Parking at Amman

Univ. of New England

TO: Shukria Wiar, Planner
FROM: David Senus, P.E.
DATE: November 30, 2011
RE: UNE Armory Parking

Project Name:	UNE- Armory Parking Project	ID:	2011-383
Address:	772 Stevens Avenue	CBL:	145-B-18
Applicant:	University of New England		
Planner:	Shukria Wiar		
RE:	Amended Approval Letter

5 LEVEL SPREADER - GRASS
SCALE: N.T.S.

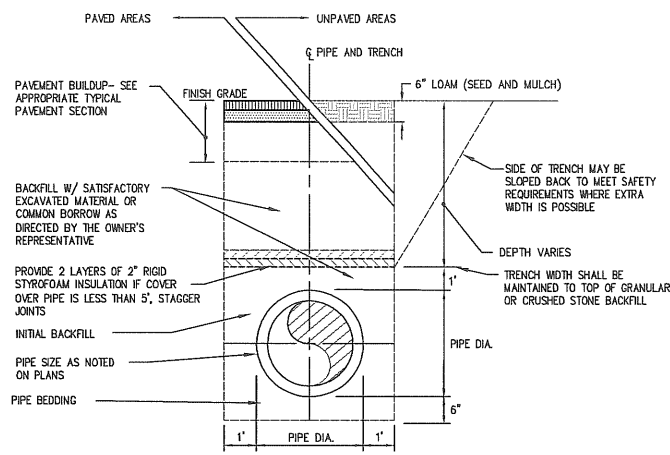
8. The site plan and details are unclear as to the application of level lip spreaders, rip-rap outlet protection, or a combination of these two practices at the outfalls on the site. A similar symbol is used for each, and the orientation of the spreader / apron is unclear from the site plan. In addition, the level spreader detail does not show the outfall location and orientation relative to the level lip. The final site plan and level spreader detail shall be clarified to show the design intent and submitted for review and approval by the Planning Authority and Department of Public Services within thirty (30) days of the date of this letter and prior to the issuance of a certificate of occupancy.

- The site plan and details are unclear as to the application of level lip spreaders, rip-rap outlet protection, or a combination of these two practices at the outfalls on the site. A similar symbol is used for each, and the orientation of the spreader / apron is unclear from the site plan. In addition, the level spreader detail does not show the outfall location and orientation relative to the level lip. The site plan and level spreader detail should be clarified to show the design intent.

7. The plans have been revised to show outlet protection at the 15 inch diameter outlet and the two 8 inch diameter outlets from the gravel pads.
8. The plans have been modified to clarify the outlet protection.

7 TYPICAL CATCH BASIN (CB)
SCALE: N.T.S.

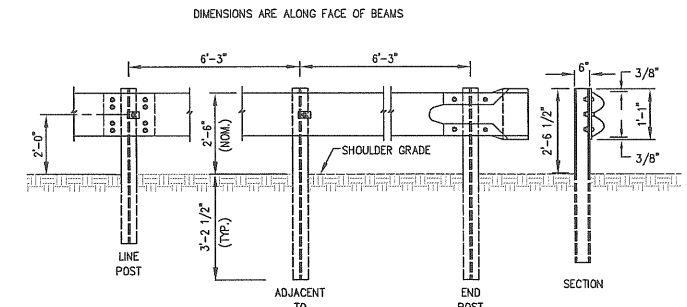
9. All of the proposed catchbasins on site shall have a three-foot sump and a Casco Trap.
10. A snow storage/removal maintenance plan shall be submitted to show the protection of the water quality of the Brook, for review and approval by the Department of Public Service within thirty (30) days of the date of this letter and prior to the issuance of a certificate of occupancy.

9. Acknowledged.
10. The plans now show the current location of the snow removal gates and the snow removal area. This information differs from that shown on the plans submitted on December 5, dated December 2. In reviewing the snow removal areas with the MEARNG, the current locations for the gates and the area were selected as the only areas with the suitable topography for storing and filtering the snow. The snow storage area will be cleared of trees and brush. Stumps will remain and there will be no grubbing or disturbance of the ground surface. An erosion
